DEPARTMENT OF TRANSPORTATION

Contract #: 04-0120F4Cty: SF/ALA Rte: 80 PM: 13.2/13.9File #: 69.25B**QUALITY ASSURANCE -- NON-CONFORMANCE REPORT****Location:** Changxing Island, Shanghai, PRC**Report No:** NCR-000275**Prime Contractor:** American Bridge/Fluor Enterprises, a JV**Date:** 25-May-2009**Submitting Contractor:** Zhenhua Port Machinery Company, Ltd (ZPMC), Changxing Island**NCR #:** ZPMC-0249**Type of problem:****Welding****Concrete****Other****Welding****Curing****Procedural****Bridge No:** 34-0006**Joint fit-up****Coating****Other****Component:** North Tower, Lift 3, Skin E**Procedural****Procedural****Description:** North Tower, Lift 3, Skin E**Reference Description:** Inadequate preheat on North Tower, Lift 3, Skin E doubler plate welds**Description of Non-Conformance:**

Subject: NCR No. ZPMC-0249

Job Name: SAS Superstructure

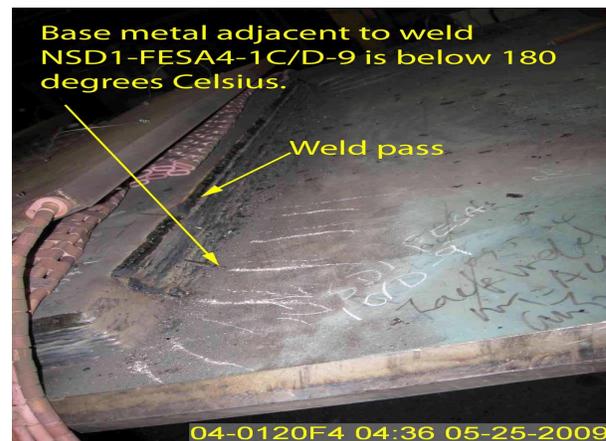
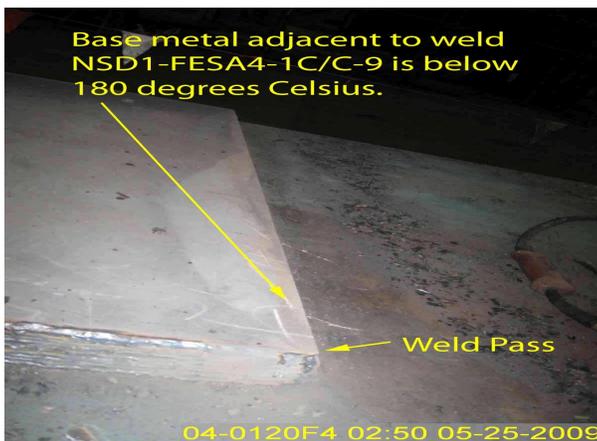
QA observed ZPMC personnel welding North Tower, Skin E, Lift 3 doubler plate welds

NSD1-FESA3-1D/D-9, NSD1-FESA3-1DD-18 and NSD1-FESA3-1C/D-9 without the required base metal preheat. The photographs below indicate an unmelted 180 degree Celsius temperature indicating crayon adjacent to welds NSD1-FESA3-1C/D-9 and NSD1-FESA3-1D/D-9.

Welding procedure WPS B-T-4332-TC-P6-F requires a minimum base material preheat temperature of 180 degrees Celsius.

Report No: NCR-000275

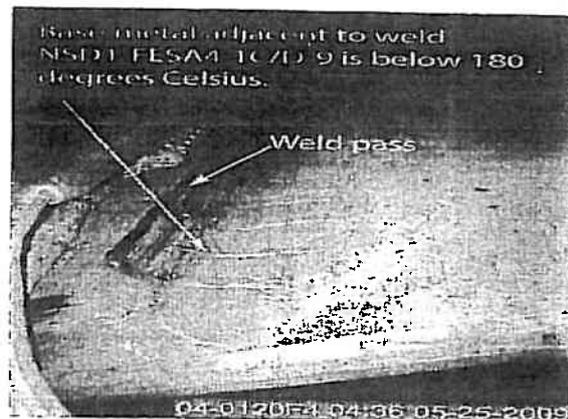
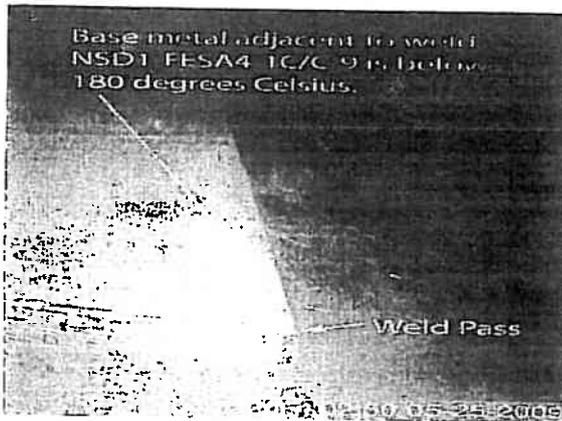
QA observed ZPMC personnel welding North Tower, Skin E, Lift 3 doubler plate welds NSD1-FESA3-1D/D-9, NSD1-FESA3-1DD-18 and NSD1-FESA3-1C/D-9 without the required base metal preheat. The photographs below indicate an unmelted 180 degree Celsius temperature indicating crayon adjacent to welds NSD1-FESA3-1C/D-9 and NSD1-FESA3-1D/D-9.

Welding procedure WPS B-T-4332-TC-P6-F requires a minimum base material preheat temperature of 180 degrees Celsius.

Report No: NCR-000285

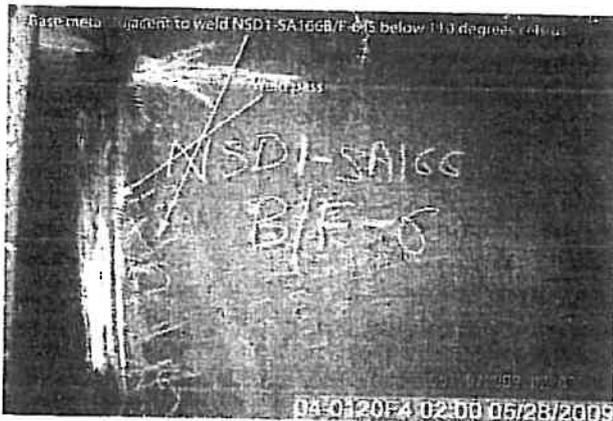
QA observed ZPMC personnel welding North Tower, Lift 2, Skin A doubler plate weld NSD1-SA166B/F-6 without preheating the weld and adjacent base material.

Welding procedure WPS-B-T-4332-TC-P6-F requires a minimum base material preheat temperature of 180 degrees Celsius.

Report No: NCR-000275

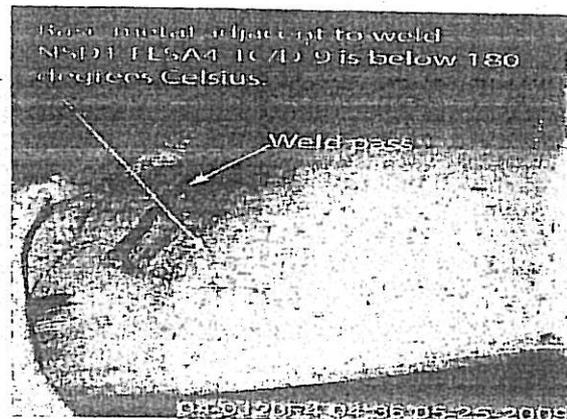
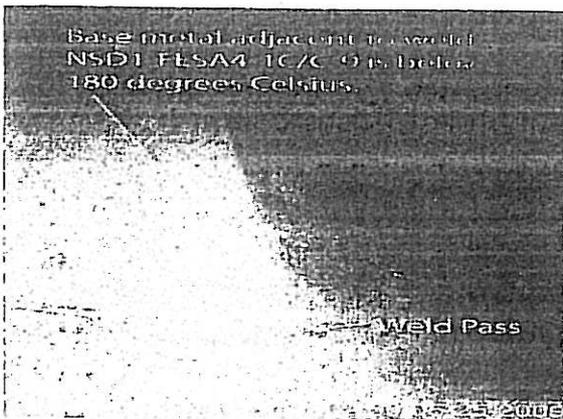
QA observed ZPMC personnel welding North Tower, Skin E, Lift 3 doubler plate welds NSD1-FESA3-1D/D-9, NSD1-FESA3-1DD-18 and NSD1-FESA3-1C/D-9 without the required base metal preheat. The photographs below indicate an unmelted 180 degree Celsius temperature indicating crayon adjacent to welds NSD1-FESA3-1C/D-9 and NSD1-FESA3-1D/D-9.

Welding procedure WPS B-T-4332-TC-P6-F requires a minimum base material preheat temperature of 180 degrees Celsius.
